D Response to Comments on the Draft Environmental Impact Statement

On Wednesday, 05June2002, a notice that the Draft Environmental Impact Statement (DEIS) was available for review on the Colville National Forest web site was mailed to planning participants. On that same date, DEIS hardcopies and digital CD copies were mailed to those who requested it. On Friday, 28June2002, The Environmental Protection Agency published a notice of availability for the DEIS in the Federal Register. This notice initiated the required 45 day comment period for the DEIS. The comment period ended Monday, 12August2002.

Public review generated seventy-five comment letters. From these, 189 comments were extracted. Comments are grouped into eleven categories, which correspond with the sections of this appendix:

Quartzite Planning Area

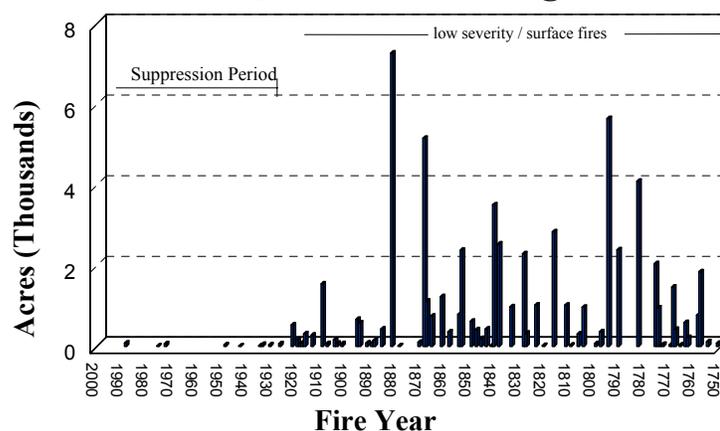
- 17) The report (*Report to the Colville National Forest on the Results of the Quartzite Planning Area Fire History*) states that 1920 is the "cutoff date for historical analysis because of an abrupt change in fire frequency and size after that date." Yet the Conclusion chapter of the document makes clear that one of the purposes of the document was to compare pre-1920 fire history with post-1920 fire history, stating that "in many instances,

the Quartzite Planning Area is out of synchrony with historic MFFIs by a factor of 10.” How can this be known without an analysis of post-1920 fire history to which the pre-1920 fire history is compared?

Successful fire suppression is the main factor in the limited numbers of acres burned after 1920 in the Quartzite Planning Area. When a fire has occurred in Quartzite after 1920, suppression efforts have so far been able to postpone the risk of stand replacing fire. It would be quixotic to believe that this trend can continue indefinitely. One only has to look at the part of the Mud Creek area (Everett et al. 2000) that burned in the 1994 Tyece fire on the Wenatchee National Forest as one of many examples where the risk of stand-replacing fires due to increasing fuel loadings was

Acres burned from 1750 to present. Pre-suppression fires were predominantly low-severity surface fires. The 1994 Tyece fire, a portion of which burned the Mud Creek study area, was a high-severity stand replacement fire and occurred decades after fire suppression began. Because of suppression, fuel loadings and arrangements were conducive to this stand-replacement event.

delayed only so long by successful fire suppression (see figure at right). So far, containment efforts have been successful in Quartzite but as the Tyee fire example shows, catastrophic stand-replacing fires can occur in an area of historically frequent/low-intensity fire because of decades of fuel accumulation.
